CALIFORNIA PUBLIC UTILITIES COMMISSION
Safety and Enforcement Division
Wildfire Safety and Enforcement Branch

Incident Investigation Report

Incident Number: E20211223-01 (Brewer Fire)

Regulated Utility Facilities Involved: Higgins 1103 12kV Distribution Circuit

Figure 10: FLIR image from October 29, 2020 inspection of Switch 2295 showing maximum and differential temperature between two jumper connections. The temperature differential measured is 245.2°F.

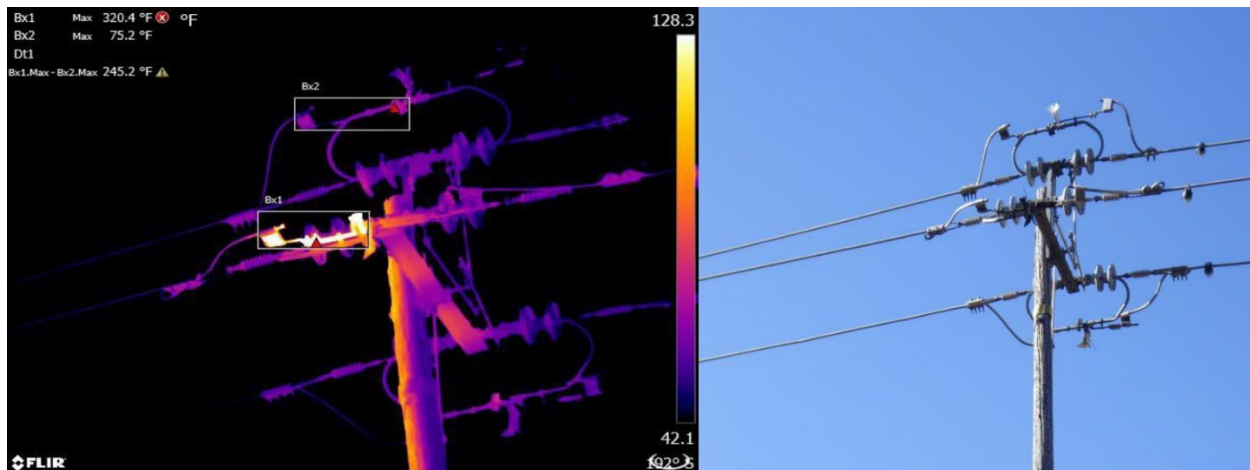
The Forward Looking Infrared (FLIR) image attached to the October 29, 2020 IR inspection report (Figure 10) showed a hot spot temperature of 320.4°F at the overheating jumper connection, and a normal temperature of 75.2°F at a normal jumper connection, which equates to a 245.2°F temperature differential (ΔT).¹⁴ The image shows an elevated temperature which is not visible to the naked eye. PG&E Procedure TD-2022P-01 provides a table which indicates priority levels for overheating equipment based on the absolute hot spot temperature (Figure 11).¹⁵

Based on PG&E Procedure TD-2022P-01, a ΔT greater than 108°F requires an EC Tag with Priority B and requires repair work to be completed within 30 days. However, EC Tag #119998009 was created from this IR inspection as Priority E and required the repair work be completed within 180 days instead of the required 30 days per PG&E Procedure TD-2022P-01.

GO 95 Rule 31.1's requirement to use accepted good practices extends to requiring regulated utilities to follow their internal procedures, as those are accepted as good practices by the utility. PG&E Procedure TD-2022P-01 requires that elevated temperature differentials at connectors and switches greater than 108°F ΔT require an EC Tag with Priority B and require repair work to be completed within 30 days. However, EC Tag #119998009 was given Priority E and was required to be completed within 180 days when it should have been given Priority B and completed within 30 days of identification, based on its temperature differential reading of 245.2°F. PG&E's clerk and gatekeeper who created the EC Tag did not understand how to read the hot spot temperature on the FLIR image, which is the output of the IR camera.

This failure to read the FLIR directly led to the EC Tag being assigned the wrong priority for repair work for a distribution facility with a condition noted as "severe" per PG&E Procedure TD-2022P-01 "Infrared (IR) Inspections of Electrical Distribution Facilities. PG&E's failure to comply with the utility's internal procedures for repairing equipment hot spot temperatures is a violation of GO 95 Rule 31.1.
